Procter & Gamble Cogeneration Project

RESPONSES TO FIRST SET OF DATA REQUESTS FOR THE PROCTER AND GAMBLE COGENERATION PROJECT (Docket No. 93-AFC-02)

RESPONSES TO CEC DATA REQUESTS (Set 1, dated December 3, 1993)

Cooling Tower Plume Height Frequency

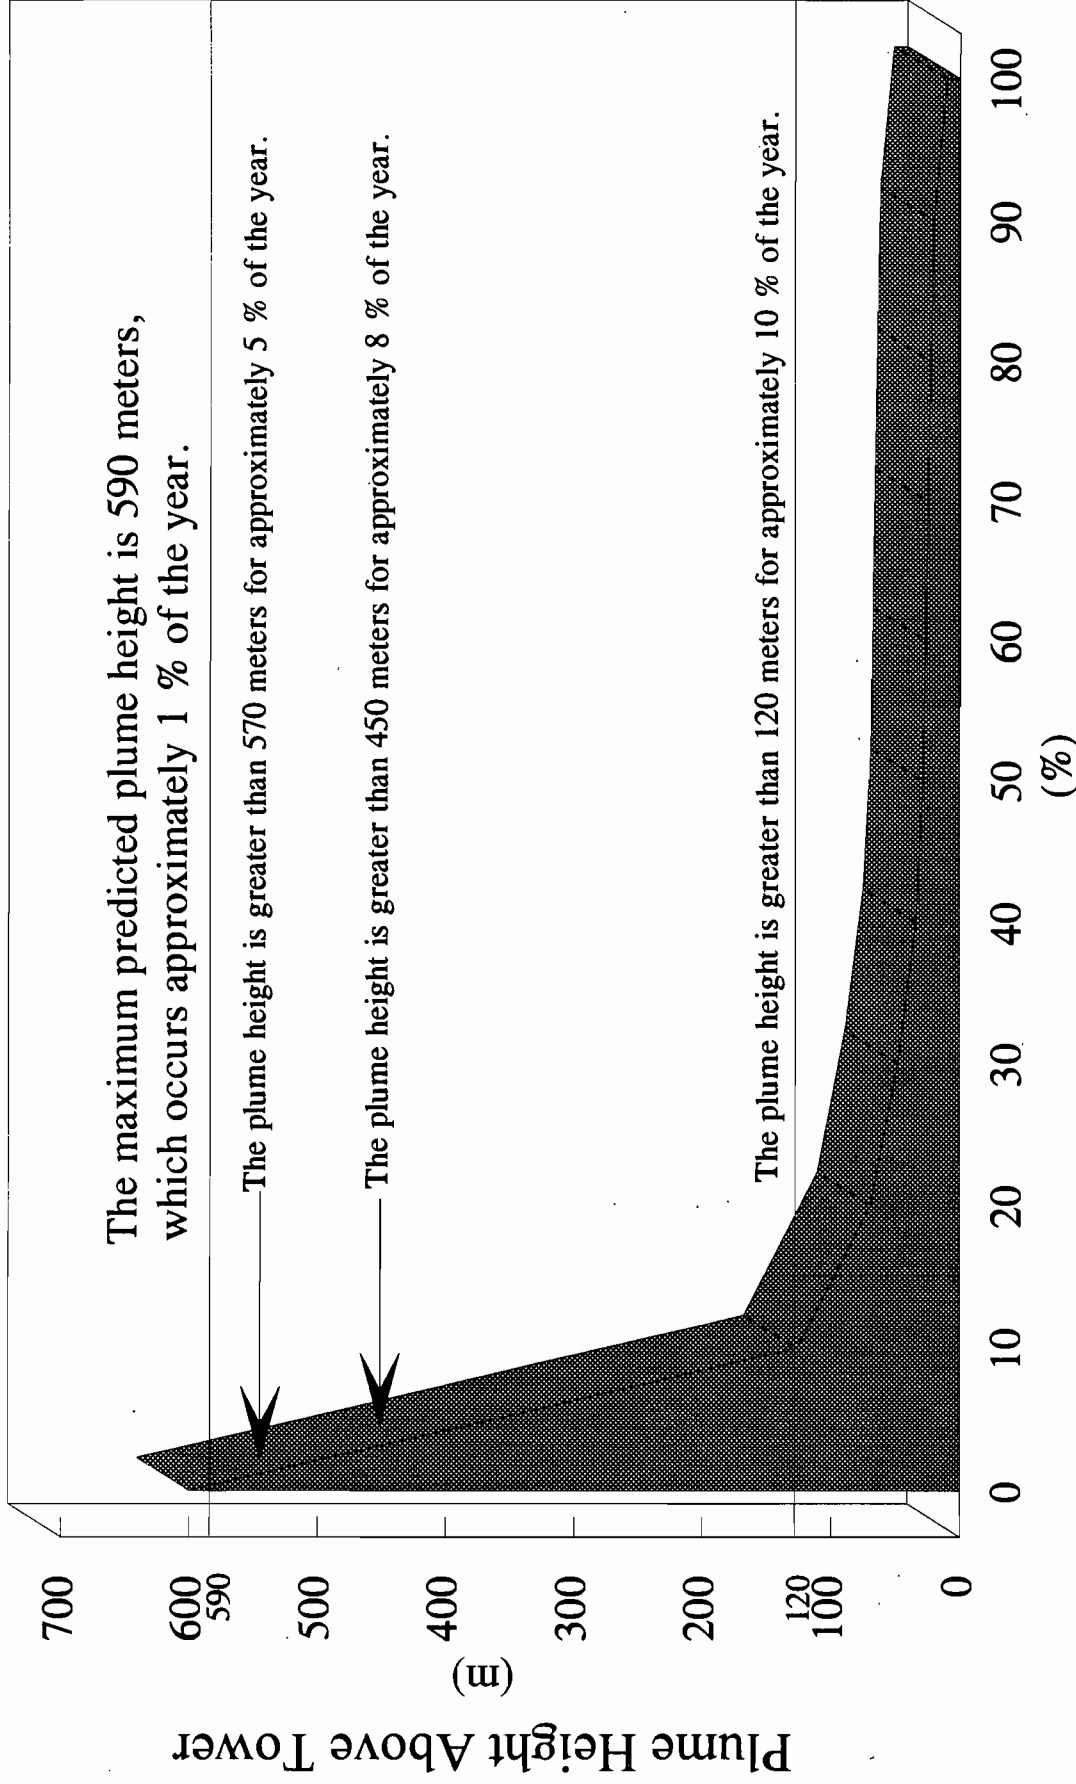
- a. Does the above indicate that the model predicted a plume height of greater than 394 feet for approximately 10 percent of the year?
- b. Please specify the maximum plume height predicted by the model.
- c. Please specify the percent of the year that the maximum plume height is predicted to occur.
- d. Please provide the SACTI model cooling tower plume results summarized on AFC p. 6.9-28.

- b. The maximum predicted plume height above the cooling tower is 1,936 feet (590 meters).
- c. The SACTI model predicted that the maximum plume height of 1,936 feet (590 meters) will occur for approximately 1 percent of the year. Additionally, to illustrate the frequency distribution of plume height throughout the year, Figure VIS-1 is attached. Figure VIS-1, which plots percent frequency distribution along the abscissa and plume height in meters along the ordinate, is based on the plume height frequency table generated in the SACTI model output.

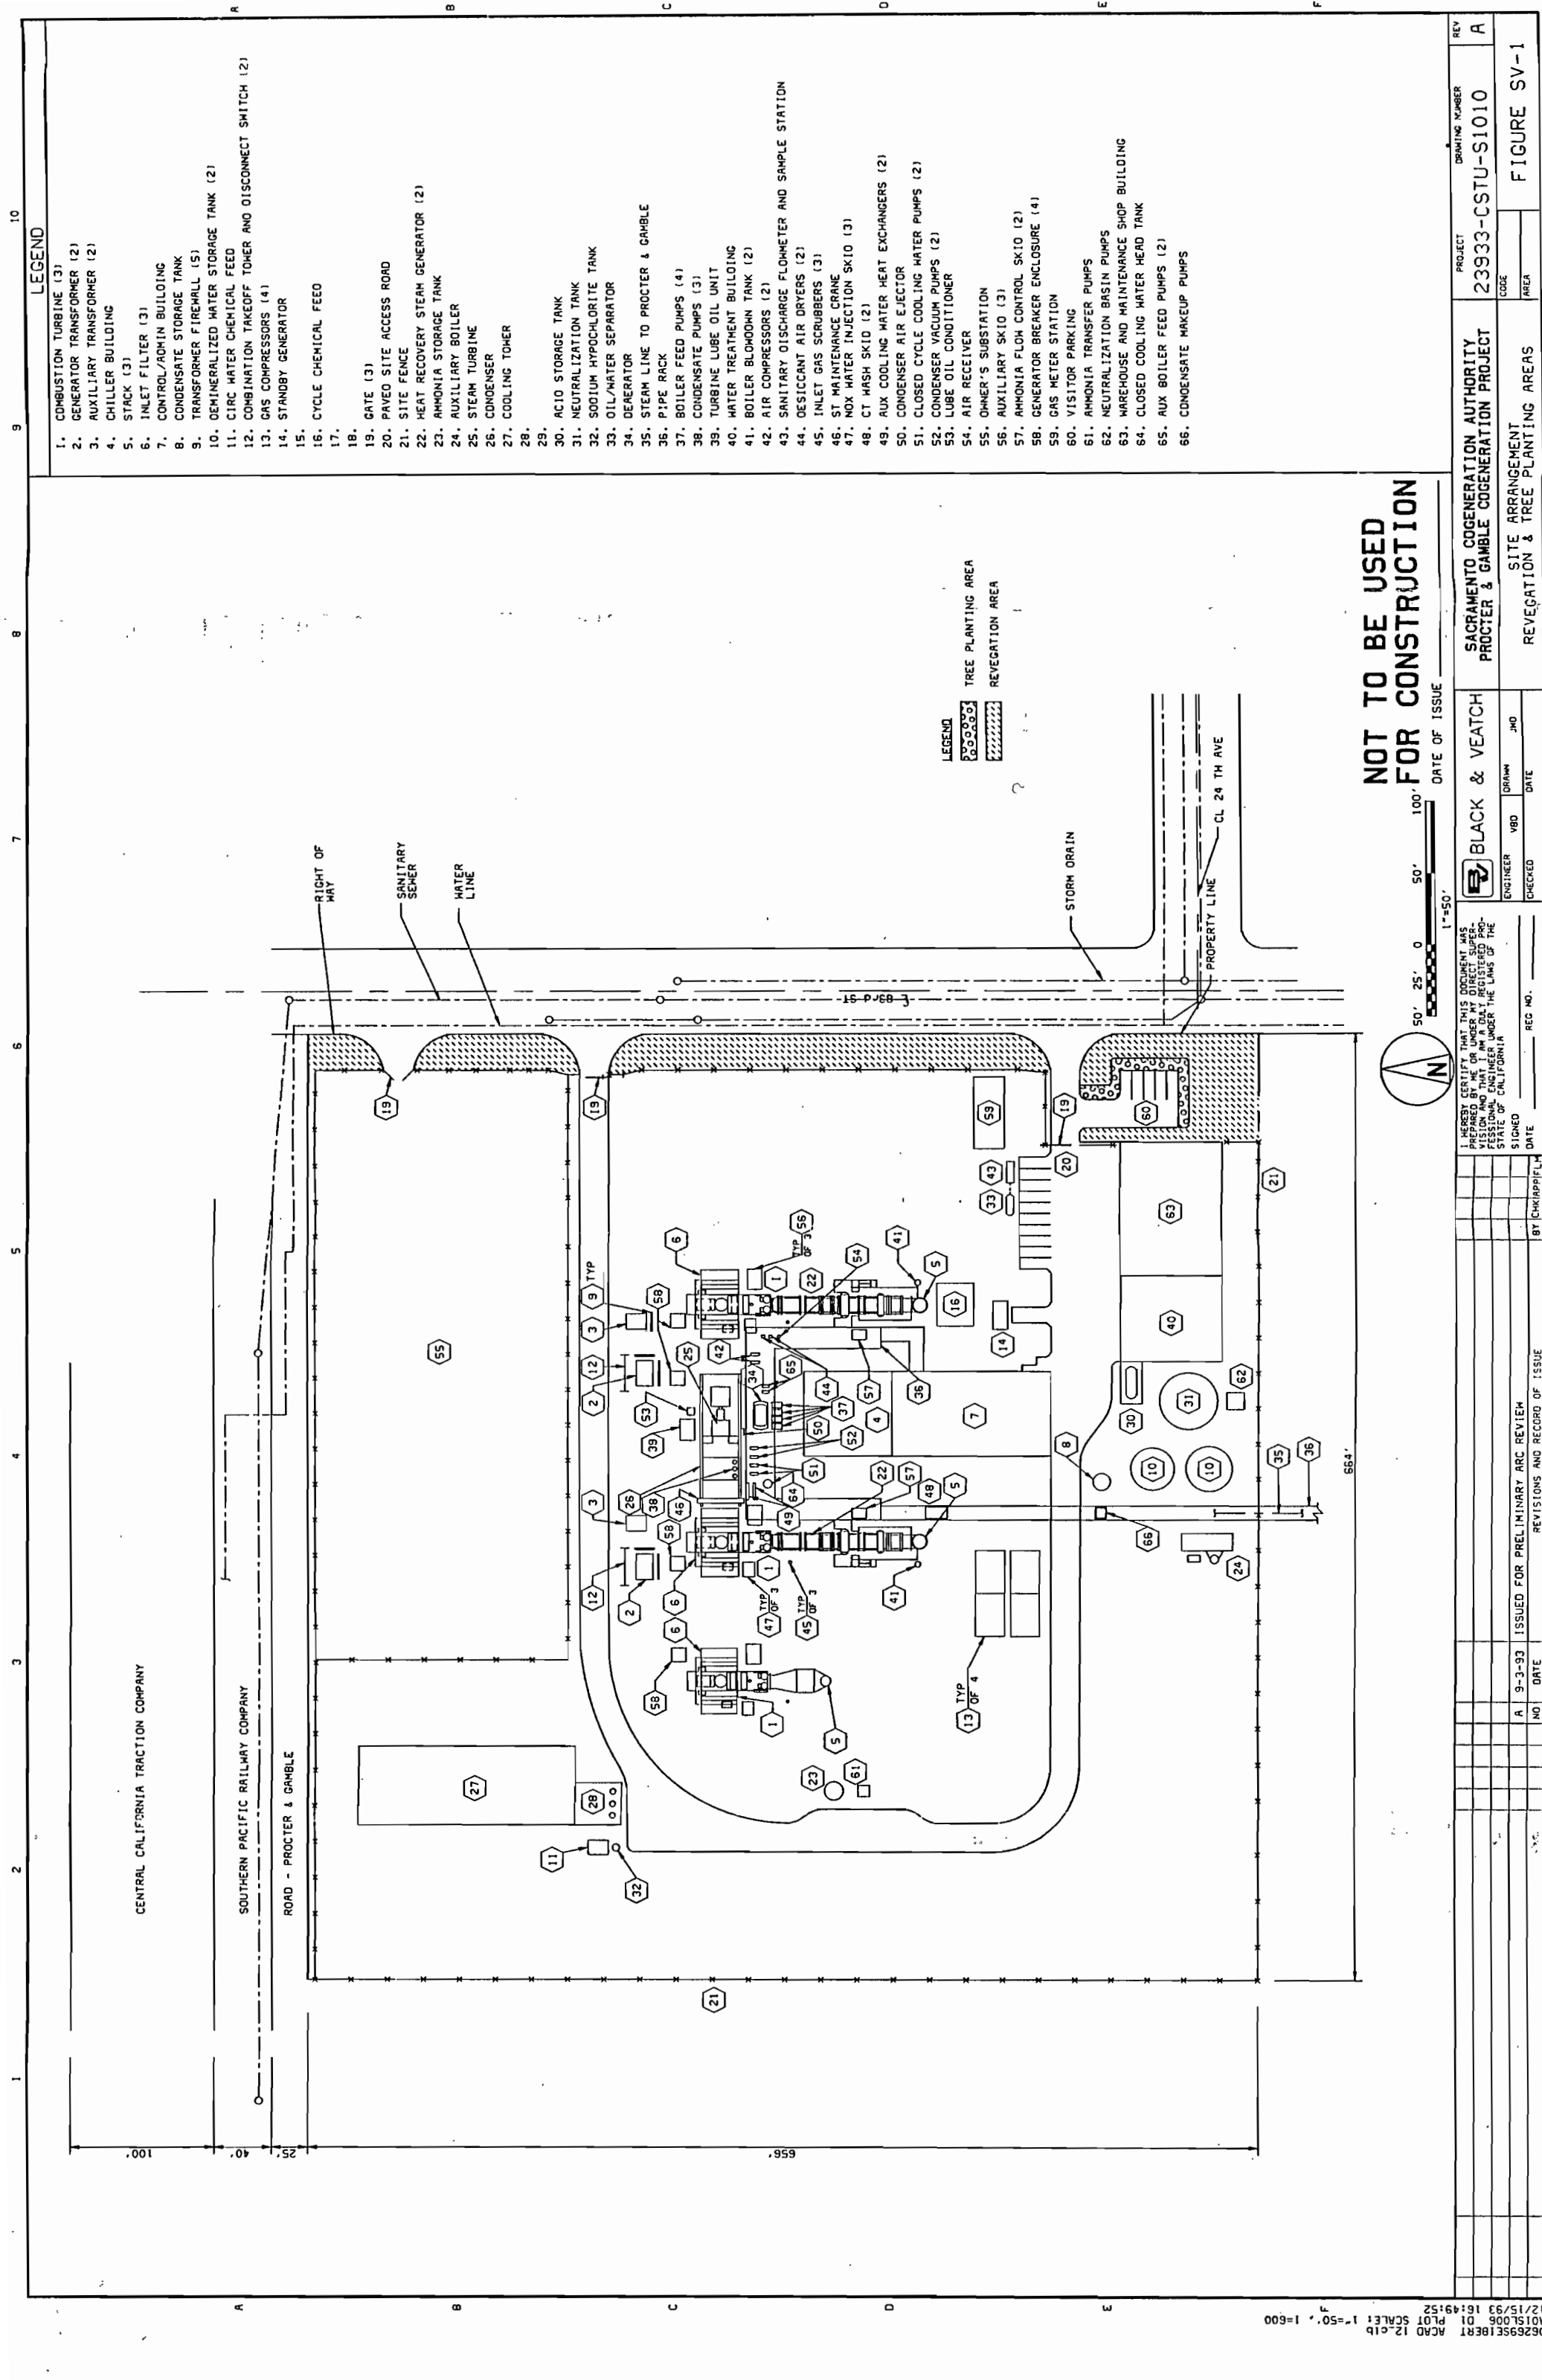
- a. *Please provide a map showing the location of the tree planting in relation to the project.*
- b. *Please specify the expected height of the trees at maturity.*
- c. *If the trees will provide screening of the project from any area from which it can be viewed by the public, please provide an artist's rendering of the effect of such screening.*

- a. Trees will be planted for shading purposes at the visitor's parking lot as shown on Figure SV-1. Planting will follow the City of Sacramento's guidelines specified in the Parking Lot Tree Shading Regulations and Water Conserving Landscape Ordinance. Requirements include a minimum of 50 percent of the parking area to be shaded, a three foot high earth berm or shrubbery to screen the parking lot from view of city streets, and the use of plants well-adapted to the regional climate. To avoid interference with project components such as pipelines, the oil/water separator for stormwater discharges, the sanitary discharge flowmeter, etc., no trees will be planted adjacent to the employee's parking lot.

- b. The two tree species, which will be planted, are valley oak (*Quercus lobata*) and sweet bay (*Laurus nobilis*). At maturity, valley oak and sweet bay reach approximate heights of 100 to 110 feet and 35 to 40 feet, respectively, depending on site conditions.

- c. The planting of shade trees in the project's visitor parking lot is proposed to comply with the City of Sacramento's shade tree ordinance. This parking area is located in the southeast corner of the project site. Industrial and commercial structures associated with Procter & Gamble and other businesses to the south and east already screen potential views of the project site from Fruitridge Road. The addition of shade trees in this area is not expected to provide significant additional screening of project features to the general public. However, the plantings will enhance the appearance of the site entrance as illustrated on the artist's rendering. The rendering (Figure VIS-2) illustrates the view from 83rd Street near its intersection with 24th Avenue looking northwest into the site.

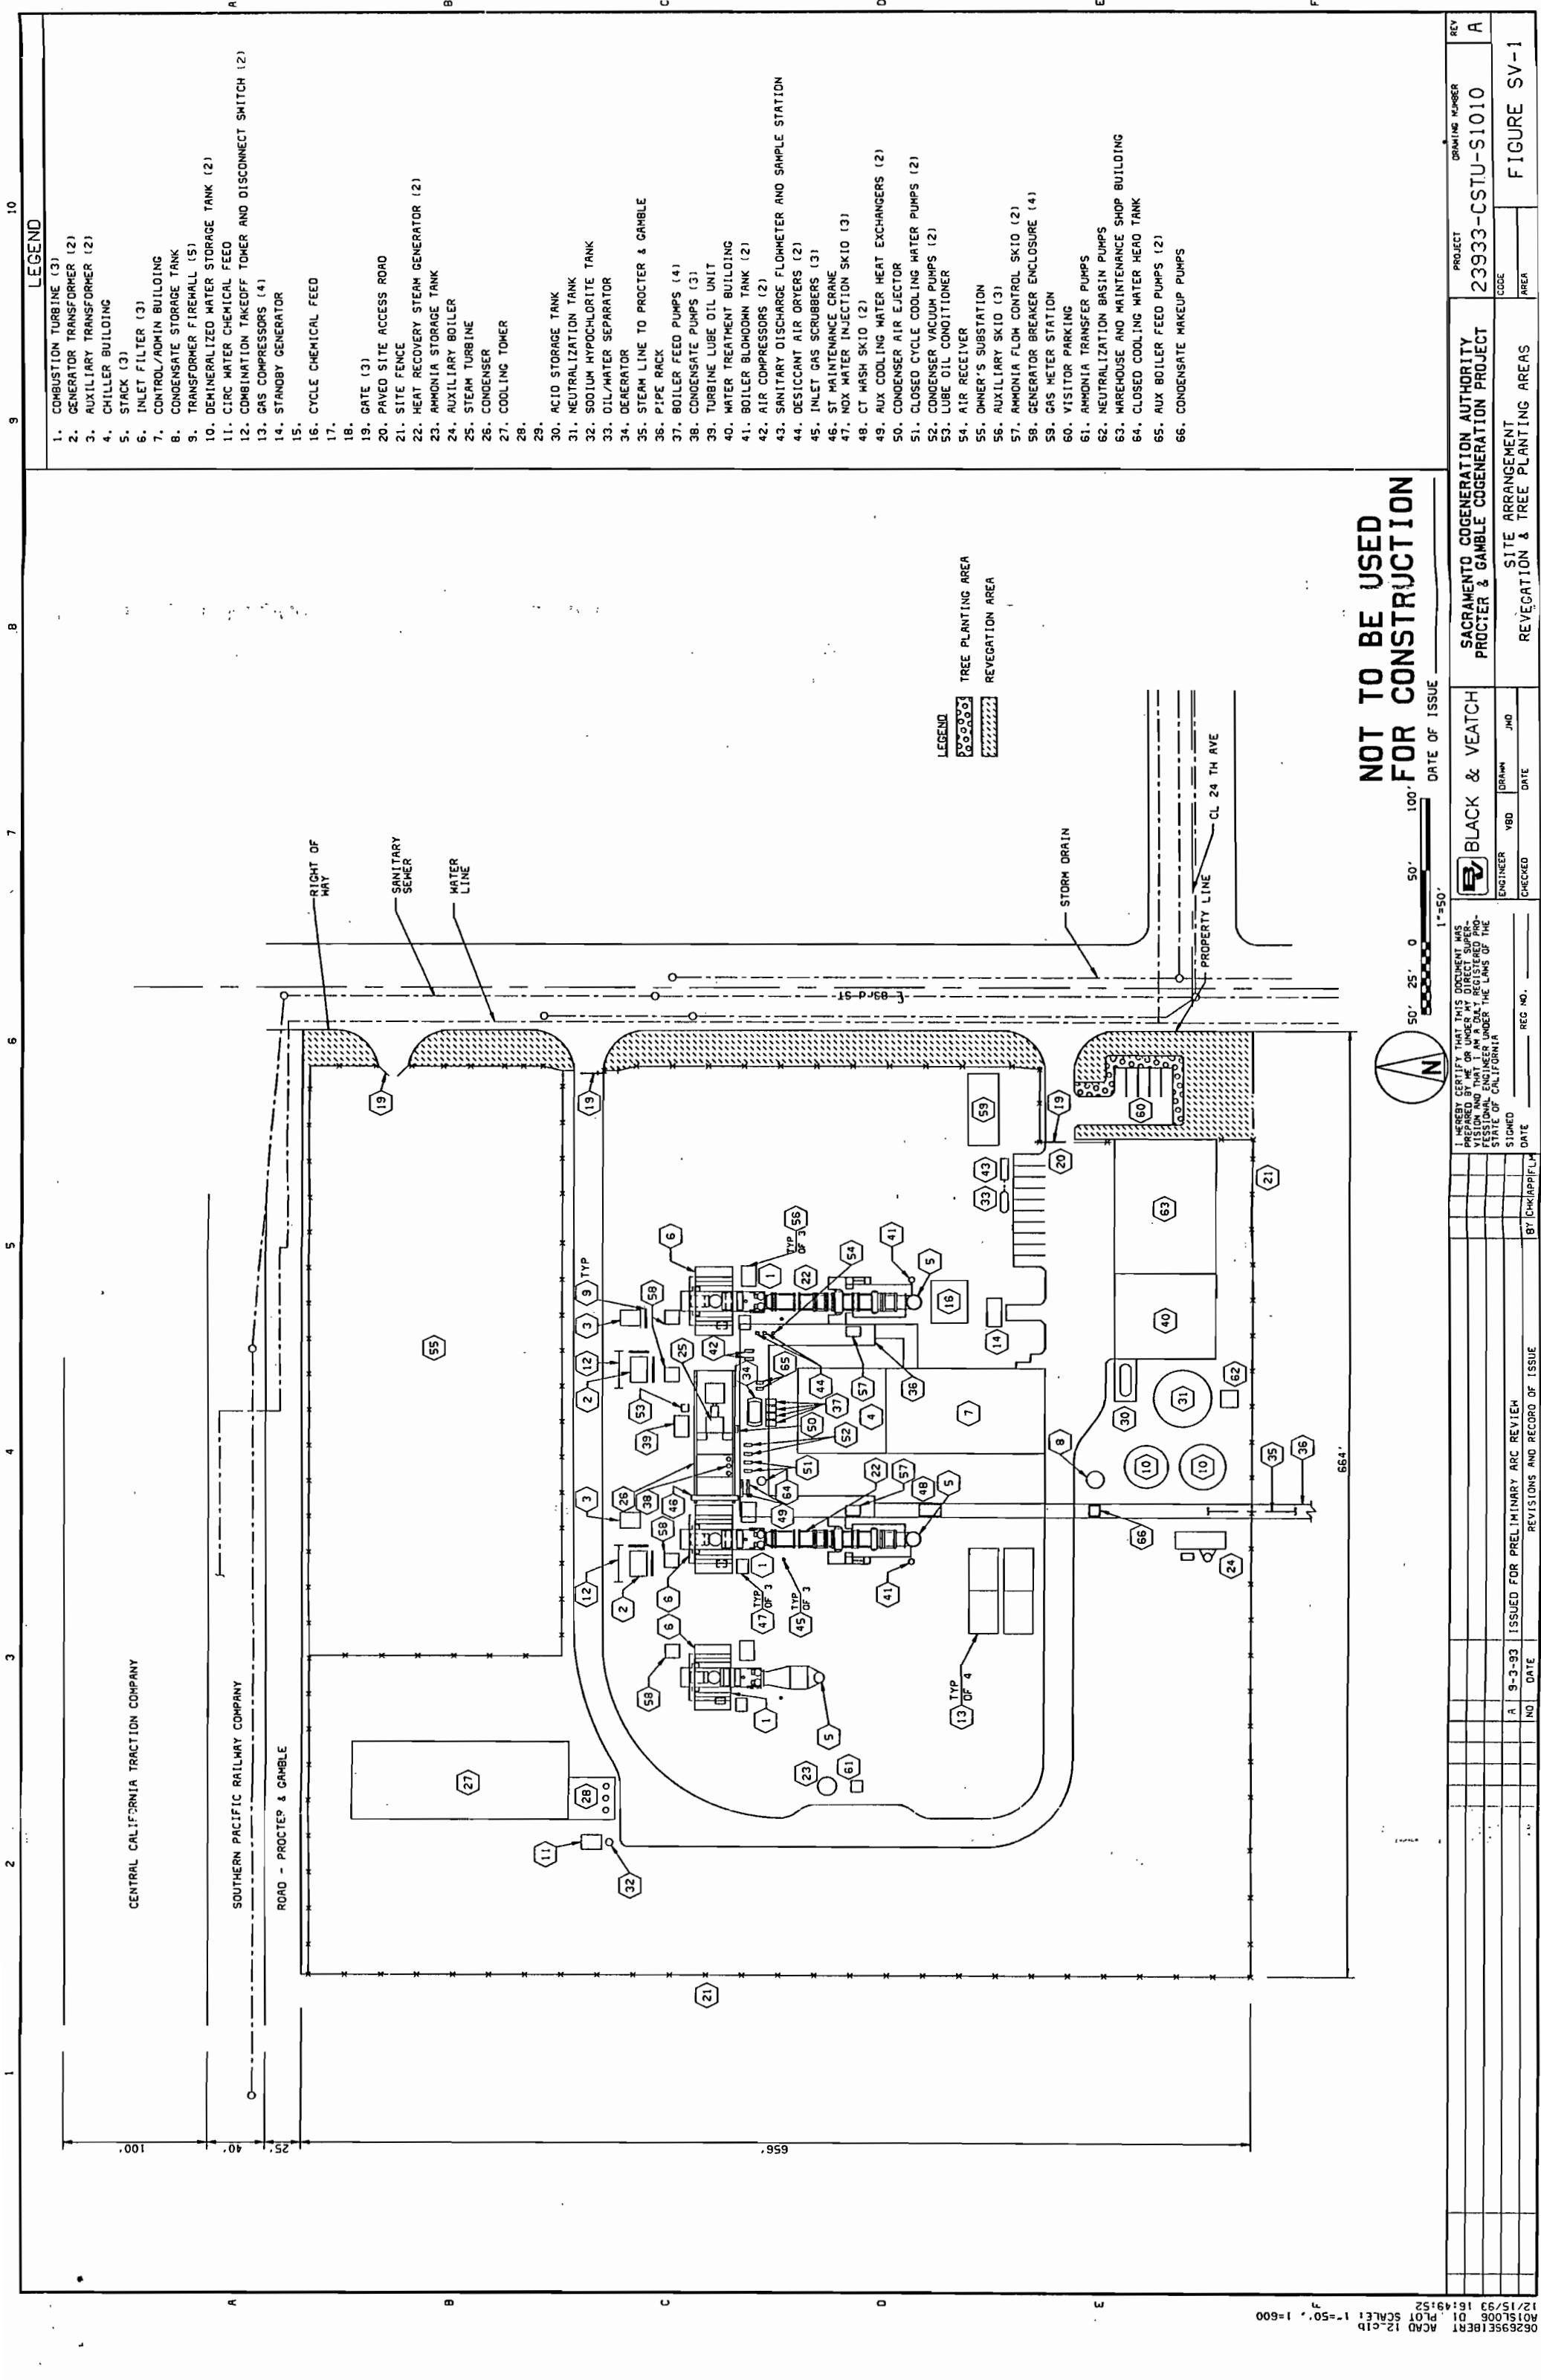
Page 6.2-10 of the AFC (revised Nov. 5, 1993) under Mitigation indicates that seeding will be one soil erosion measure that will be used. Please identify all areas to be revegetated, as well as the plant species that will be used. Planting techniques, including seeding and fertilizer rates and irrigation schedules should be identified. If container plants are to be used, the size and the planting density should also be identified.

Areas to be seeded include the narrow strip of land between the project fence and 83rd Street extending from the northwest corner of the project site to the visitor's parking lot as well as the land adjacent to the visitor's parking lot. Figure SV-1 shows these areas.

Areas will be seeded with creeping red fescue at a seeding rate of 12 pounds per acre. Seeding areas will have a firm seedbed after proper preparation such as disking, chiseling, or harrowing. A commercial fertilizer, such as one containing 16% nitrogen, 20% available phosphoric acid, and 0% water soluble potash, will be distributed uniformly over the seedbed at a rate of 500 pounds per acre. The fertilizer will be applied hydraulically by hydroseeder in the form of a slurry which will also contain the seed. A straw
